**PLANNING COMMISSION
MEETING AGENDA
SPECIAL/STUDY MEETING**

SUBJECT: PUBLIC HEARING - SPECIAL USE AND PRELIMINARY SITE PLAN REVIEW (File Number SU 403) – Proposed Fifth Third Bank ATM, Northeast Corner of John R and 14 Mile Road, Oakland Plaza, Section 36, Currently Zoned CB (Community Business) District

Preliminary Site Plan and Special Use Review For City of Troy, Michigan

Applicant:	Fifth Third Bank
Project Name:	ATM at Oakland Plaza
Plan Date:	February 18, 2013
Location:	Northeast Corner 14 Mile and John R
Zoning:	CB, Community Business
Action Requested:	Preliminary Site Plan and Special Use Approval
Required Information:	Deficiencies noted

Drawing Name:
Enlarged
Site Plan

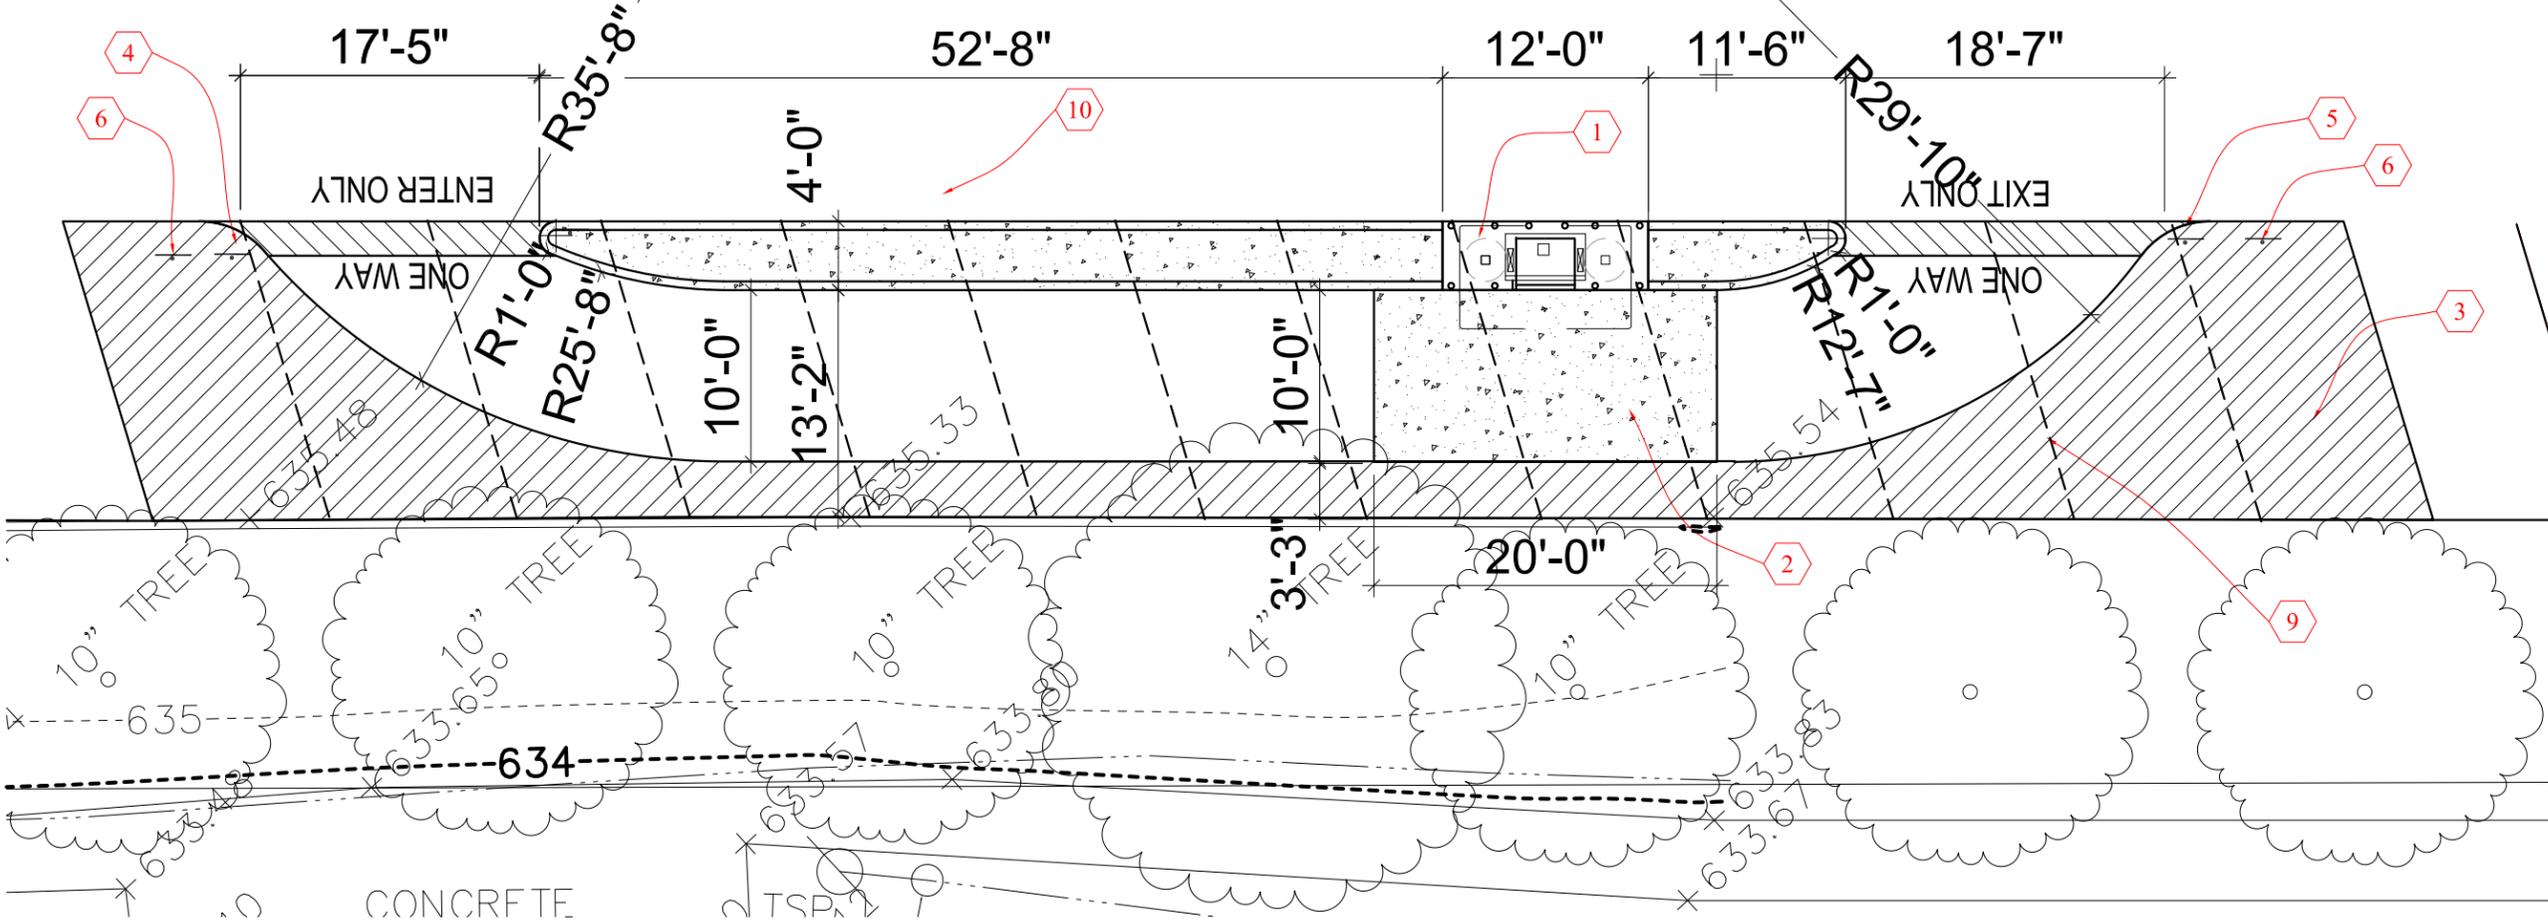
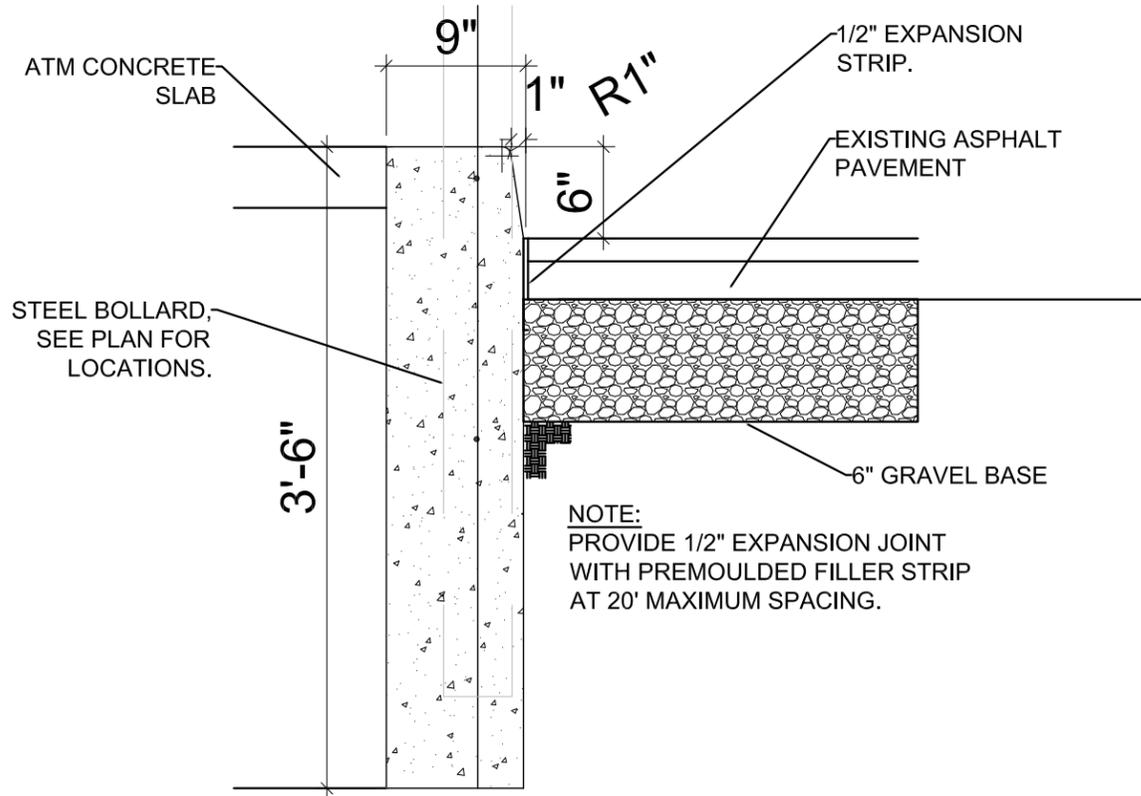
2. **Verify that mature landscaping will not be altered.**

The submitted site plan indicates that the mature landscaping along 14 Mile Road will not be altered. All work will be conducted within areas of the site that have already been graded and asphalted. There is no proposed work in the parkway along 14 Mile Road.

3. **Provide curbing adjacent to drive aisle.**

The submitted site plan indicates that the area that is adjacent to the drive-aisle will be curbed.

4. **Modify stacking spaces to meet minimum Ordinance requirements.**

The applicant has amended the site plan to provide the necessary stacking space width and length.

5. Provide an additional stacking space.

The applicant has amended the site plan to provide the necessary four (4) stacking spaces.

6. Stripe off each parking space adjacent to the proposed drive-through lane and sign as NO PARKING

The submitted site plan shows the necessary striping. NO PARKING signs shall be shown on site plan.

Items to be Addressed: Show NO PARKING sign on site plan.

Drawing Name:
Photometric
Site Plan

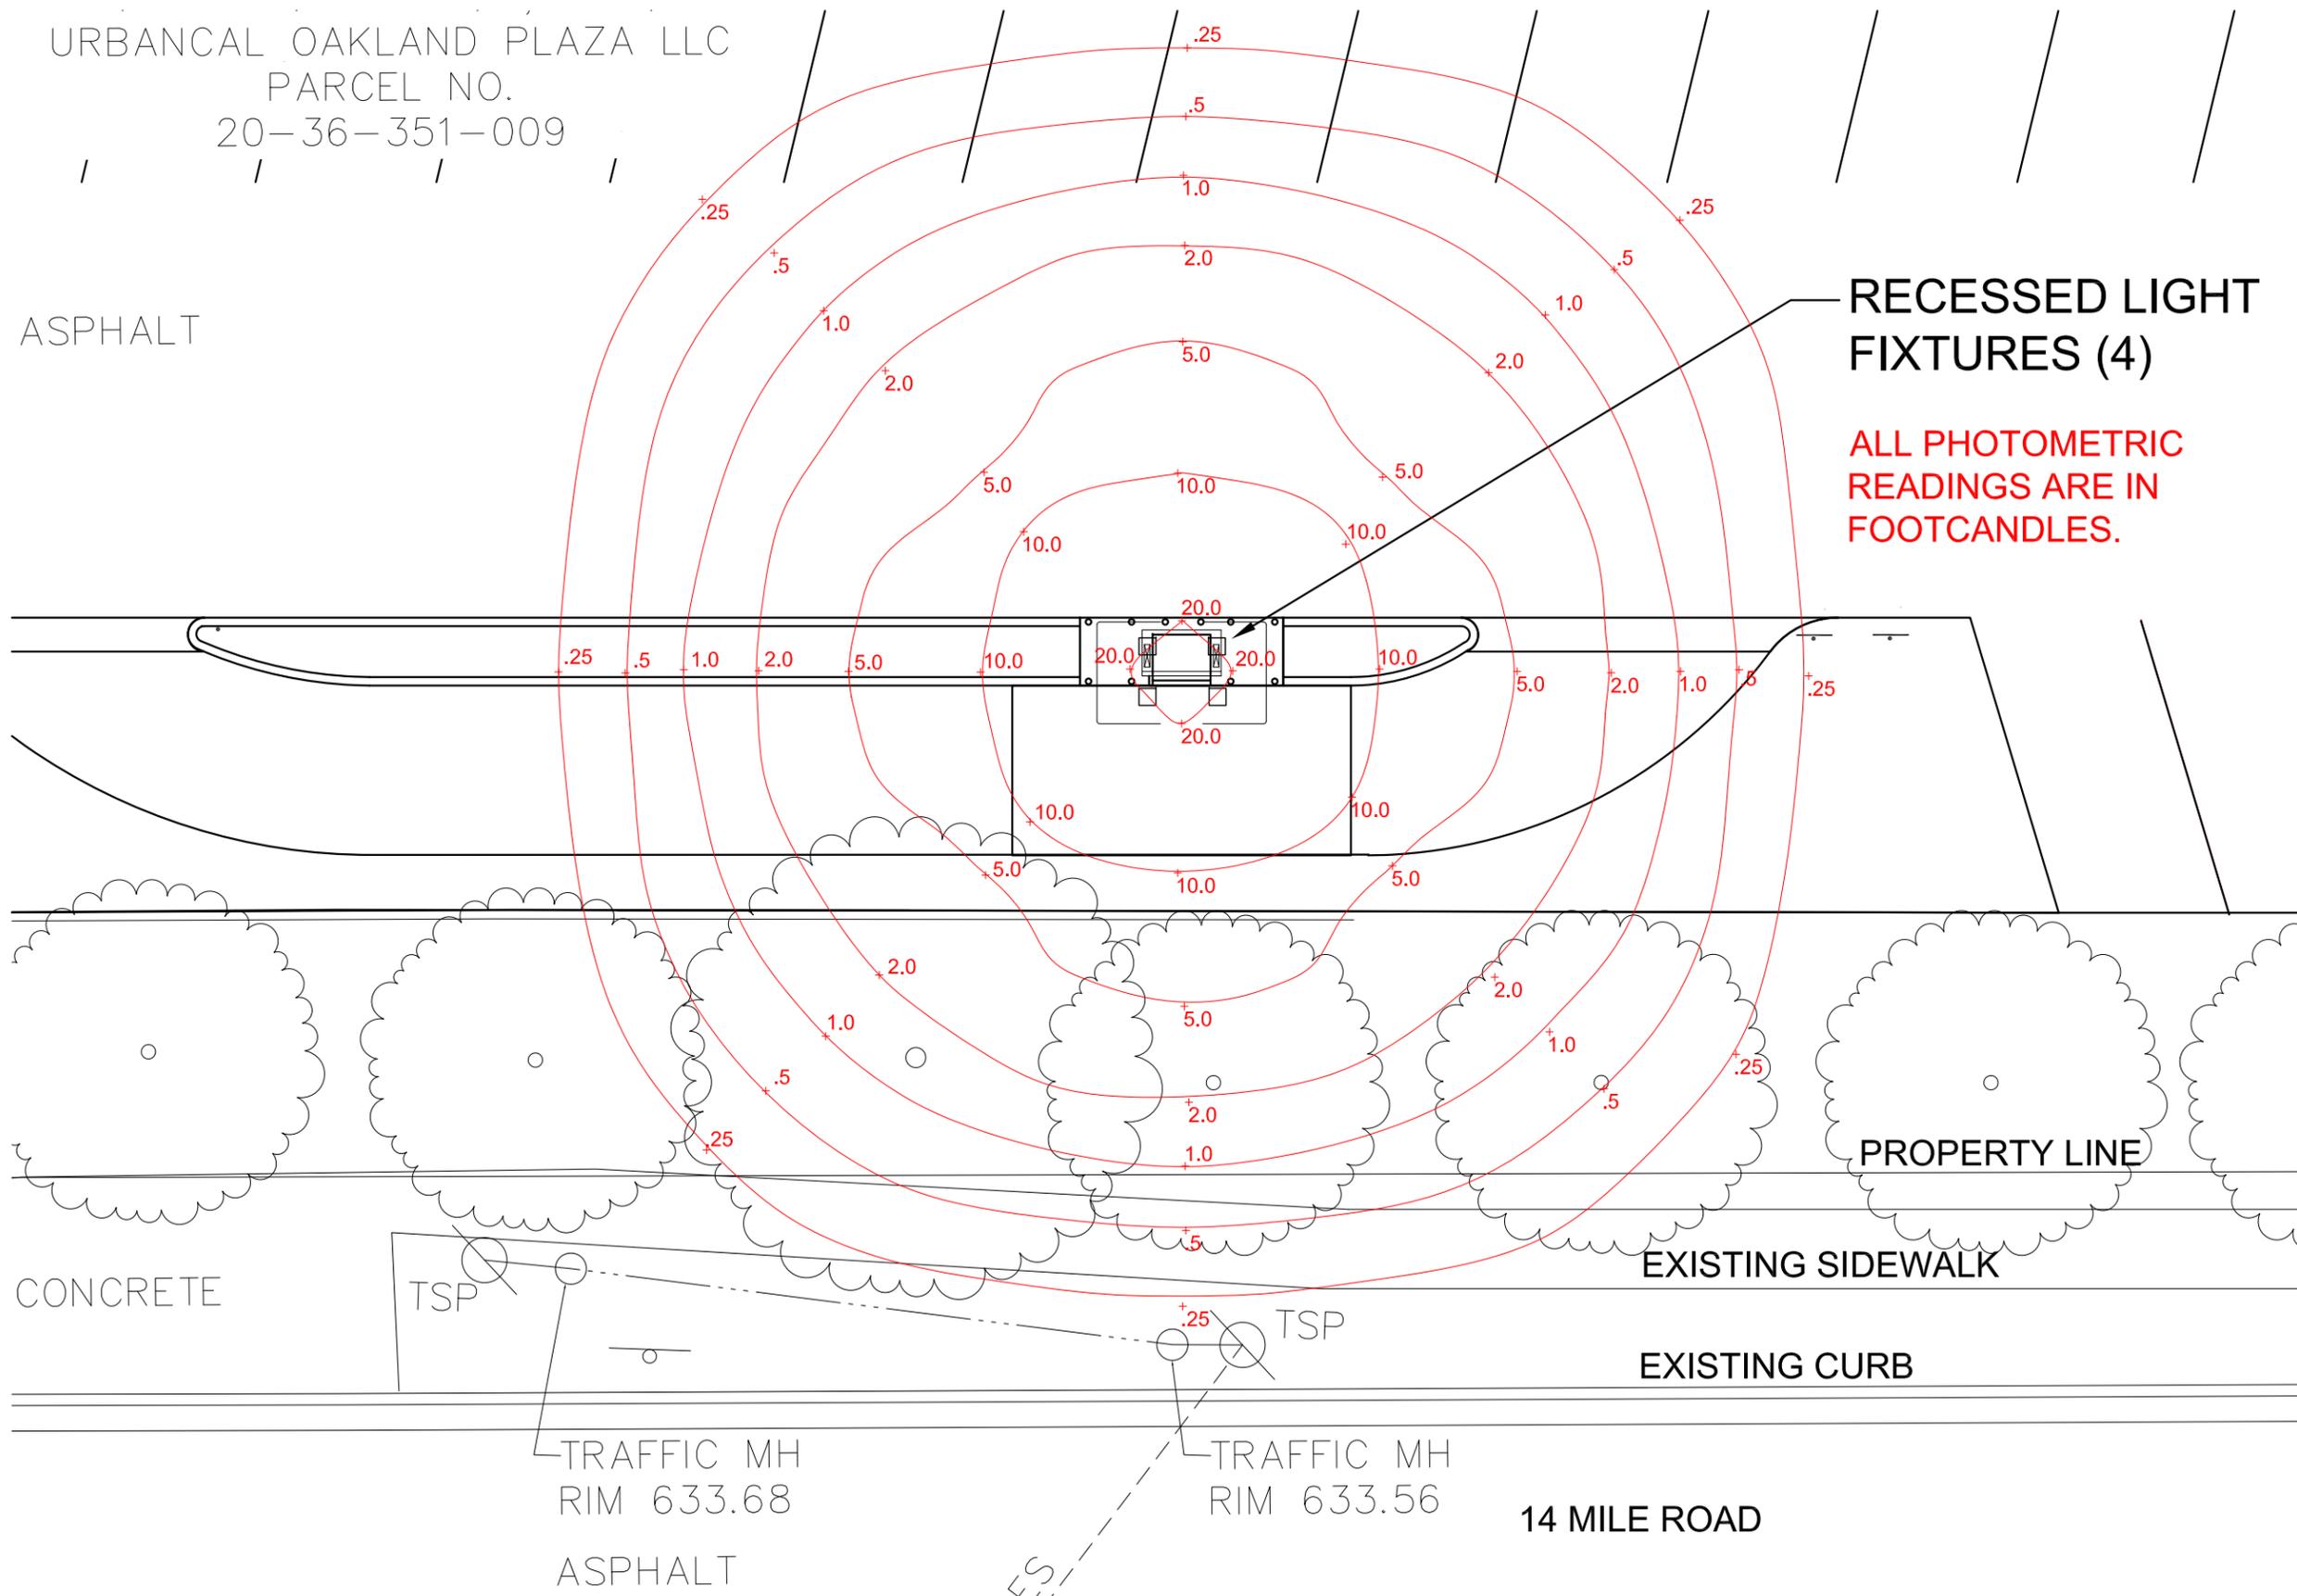
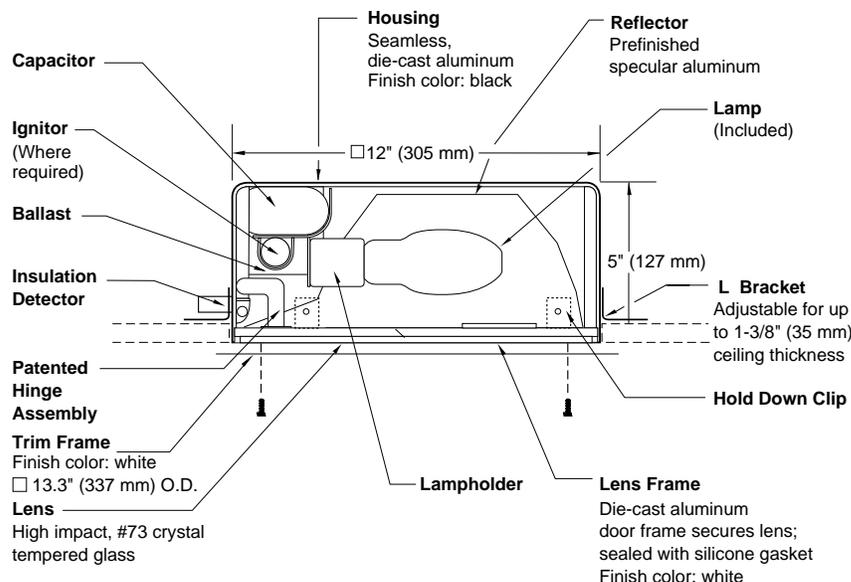
7. Confirm that lighting levels will be reduced to no more than 10-foot candles under the canopy between 11:00 p.m. and sunrise.

A recessed canopy light is proposed to illuminate the ATM at night. The photometric under the canopy is 20-foot candles, which is the maximum permitted lighting level. The applicant is seeking relief from the Planning Commission to maintain the 20-foot candle level 24 hours a day. The applicant notes the need for 20-foot candle reading based on company policy; however based on the submitted "Fifth Third ATM and Night Depository Lighting Design Standards" official company policy document, a 10-foot candle reading at night is sufficient. The applicant has not provided safety documentation and thus maintaining a 10-foot candle requirement during night hours offers a balance between safety needs and not over lighting the area.

Items to be Addressed: Reduce lighting levels to no more than 10-foot candles under the canopy between 11:00 p.m. and sunrise.

8. Reduce lighting levels below 1.0 footcandle along 14-Mile.

Due to ambient lighting along 14-Mile Road if the applicant were to reduce the lighting level between 11:00 p.m. and sunrise, the footcandle level readings along 14-Mile Road are sufficient.
